California Public Utilities Commission
Fulton-Fitch Mountain
Reconductoring Project
**Final~~Draft~~ Supplemental Initial Study/
Mitigated Negative Declaration**
State Clearinghouse No. 2017072049

August~~June~~ 2019

RESPONSE TO COMMENTS

Comment Letter A-1 (CDFW)

Figure RTC-1 Poles and Representative Work Areas near Mark West Creek

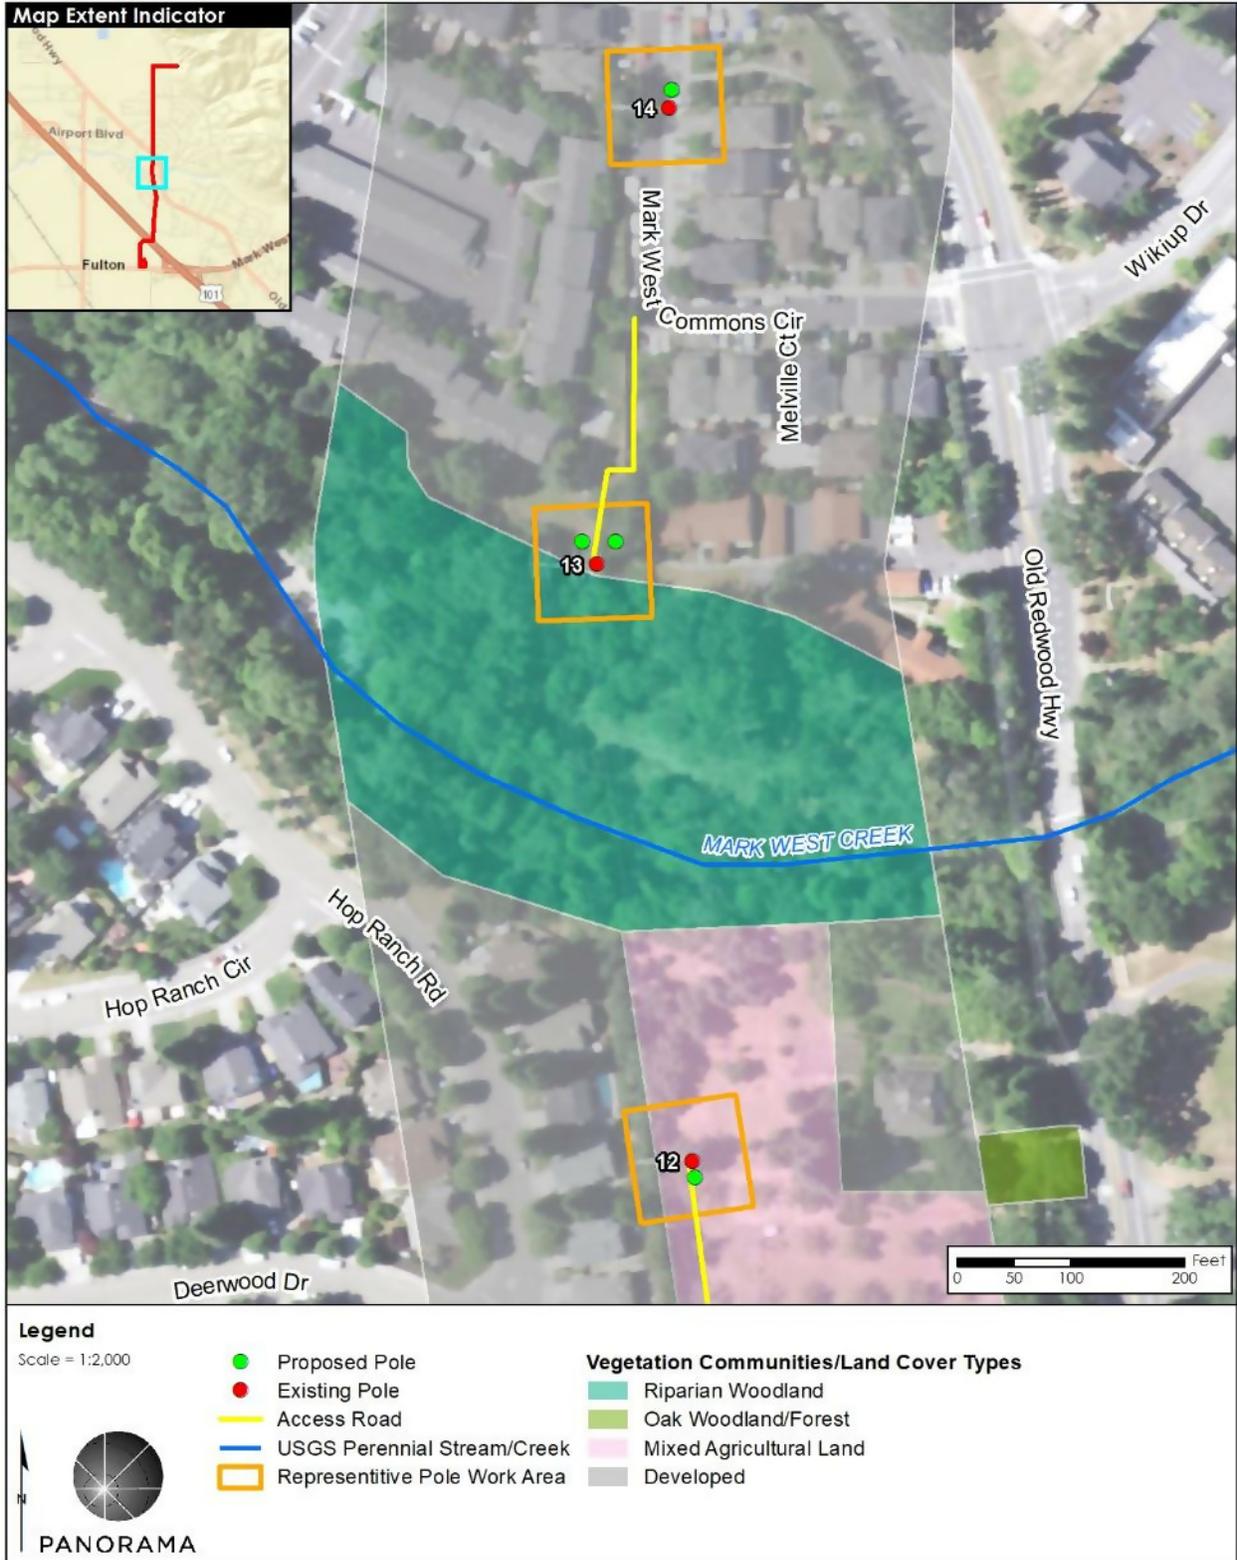
The Supplemental MND indicates that the TSP 13 replacement is located within Mark West Creek riparian habitat. This creek is documented to support FYLF including a 2016 California Natural Diversity Database (CNDDB) occurrence record approximately 1.1 miles downstream of the Project and another occurrence record upstream, both well within the species' mobility range. Adjacent uplands including the Project area may provide suitable upland habitat for the frog particularly during the wet season when the Project is proposed to occur. MM Biology-4 survey requirements indicate that only uplands within 10 feet of aquatic habitat would be considered upland habitat for FYLF and surveyed. However, different life stages of FYLF use a variety of habitat types for development, foraging, and overwintering (Thompson et al. 2016). The species utilizes upland habitats adjacent to streams and have been observed 164 feet away from streams under rocks or other refugia (Nussbaum et al. 1983; Thompson et al. 2016; Zweifel 1955). Little information is known about FYLF terrestrial movements and the species may travel farther from streams. Therefore, frogs could be significantly farther than 10 feet from aquatic habitat and be missed by the surveyor. Further, the proposed 24-hour pre-activity survey may not detect all frogs within the work area and are inconsistent with published survey recommendations for the species.

CDFW describes potentially suitable aquatic and upland habitat for FYLF along Mark West Creek and states Pole 13 is within riparian habitat along the creek. Pole 13 abuts the riparian vegetation adjacent to the Mark West Creek channel (refer to Figure RTC-1 below) but is not directly located within riparian habitat, as shown in the photos provided in Figure RTC-2 and Figure RTC-4. Pole 13 is located in a developed area (i.e., residential recreation areas with a lawn, concrete platforms, and other structures) outside of the creek channel and outside of the adjacent riparian area. The existing pole (a double-shaft structure joined at top; Figure RTC-2) would be replaced with two separated poles positioned further north of the creek and associated riparian habitat, as shown in Figure RTC-1. Access for construction equipment would be via the flat developed areas north of Mark West Creek and outside of the riparian vegetation. Although project areas near Mark West Creek are developed, areas immediately adjacent to creeks are considered potentially suitable habitat for FYLF, as described on page 3.4-22 of the 2017 MND.

To address CDFW's comment, MM Biology-4 has been revised and would be implemented to reduce potential impacts on FYLF at Pole 13 as well as any other project areas in the Southern Segment within 200 feet of potentially suitable FYLF habitat.

Pole 13 (double shaft-structure) is positioned just above the bank of Mark West Creek. The two existing poles would be replaced with two separated poles positioned farther away from the creek bank (see Figure 1). Construction would occur on the flat area in view and not within the creek channel or riparian vegetation beyond the existing poles.

Figure 2.2-1 Proposed Modifications in the Southern Segment (1 of 2)

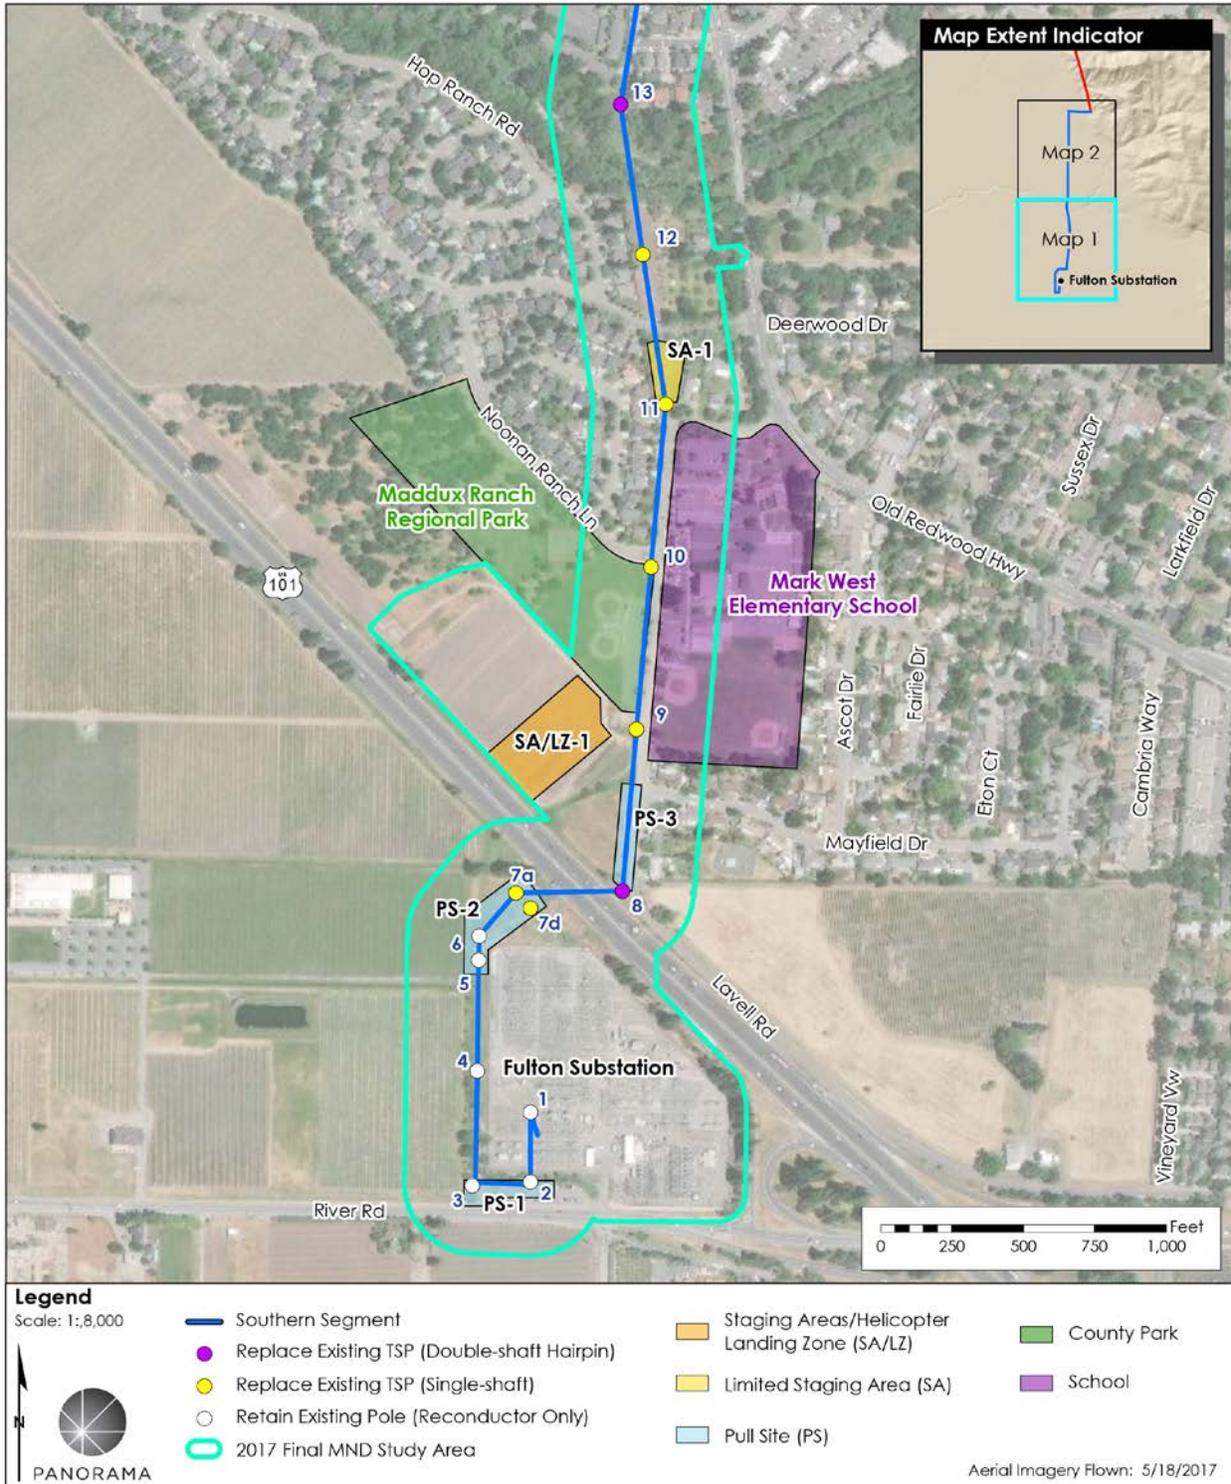
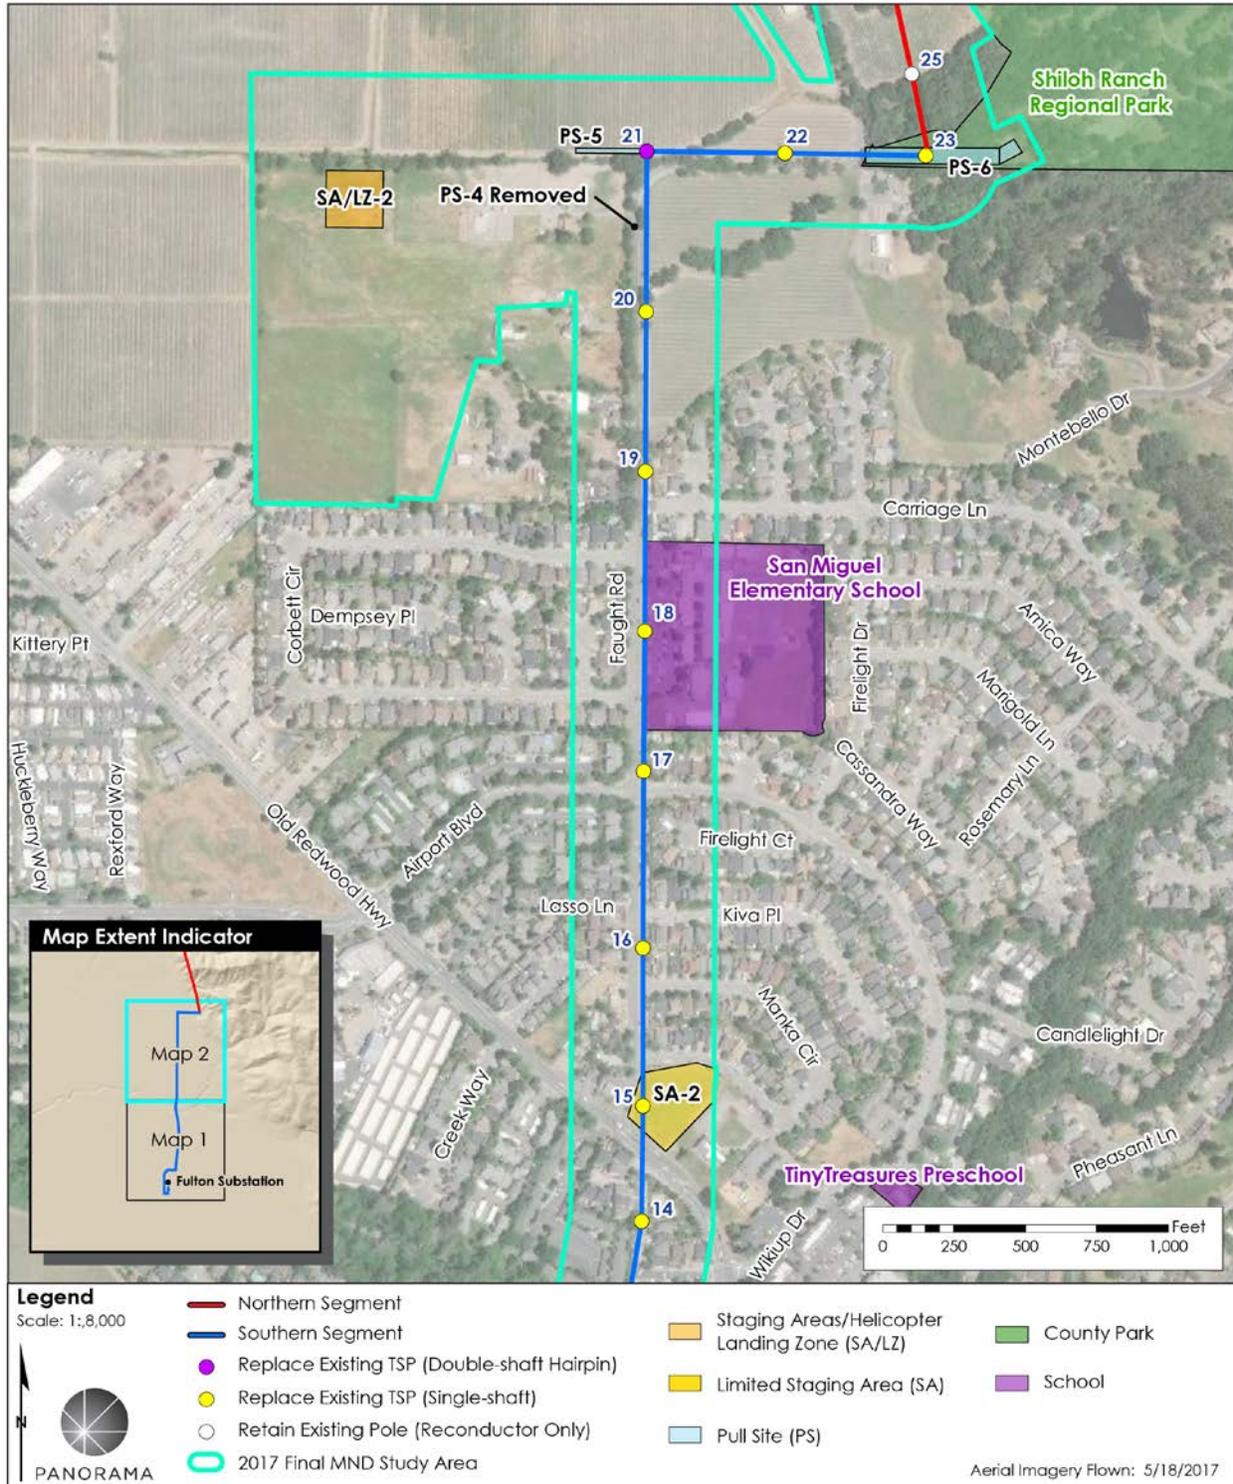
Figures 2.2-1 and 2.2-2 do not appear to show the location of TSPs that will be removed. Therefore, it is difficult to identify related impacts to biological resources. CDFW recommends that these figures include the TSP removal locations and an analysis of related impacts to biological resources including mitigation measures as necessary.

CDFW recommends that maps that show both existing pole locations and proposed new pole locations be provided in the Supplemental MND to support the biological impact analysis. CDFW also states that impacts at the new pole locations should be analyzed.

As described in the Project Description of the Supplemental MND, poles would be replaced within approximately 15 to 35 feet of existing pole locations. Maps provided in the Project Description show a single point to represent existing poles that would be replaced because, at the map scale, existing and proposed pole symbols would be congruent. The Project Description references detailed maps, which are provided in Appendix A of the Supplemental MND. The maps in Appendix A depict both existing and proposed pole locations at a larger scale and provide the detail requested. This Appendix with the detail requested was provided in the Supplemental MND. No changes to the Supplemental MND have been made related to this comment.
